ISO/IEEE 11073-20601

AMENDMENT 1
2015-03-01

Health informatics — Personal health device communication

Part 20601: Application profile — Optimized exchange protocol

Table 1—Partitions in the nomenclature

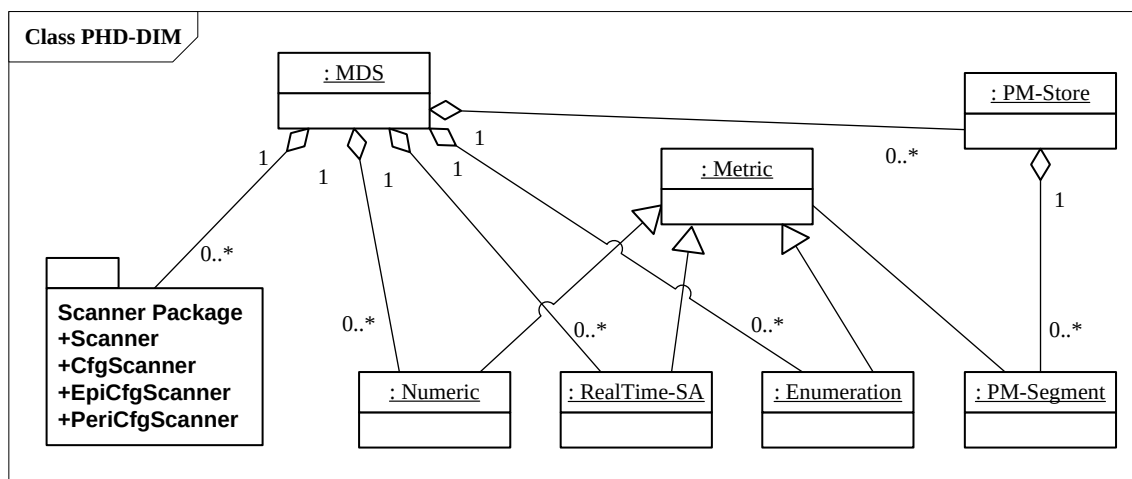
Change Table 1 as shown:

Partition number	Nomenclature category
<u>0</u>	<u>Unspecified</u>
1	Object-oriented (OO)
2	Supervisory control and data acquisition (SCADA)
3	Events
4	Dimensions (units of measurement)
5	Virtual attributes
6	Parameter groups
7	[Body] sites
8	Infrastructure
<u>9</u>	<u>File Exchange Format</u>
<u>10</u>	<u>ECG Extensions</u>
<u>11</u>	<u>IDCO Extensions</u>
<u>129–127</u>	Reserved
128	Personal health devices disease management
129	Personal health devices health and fitness
130	Personal health devices aging independently
131–254	Reserved
255	Return codes
256	External nomenclature references
257–1023	Reserved
1024	Private
1025–65 535	Reserved
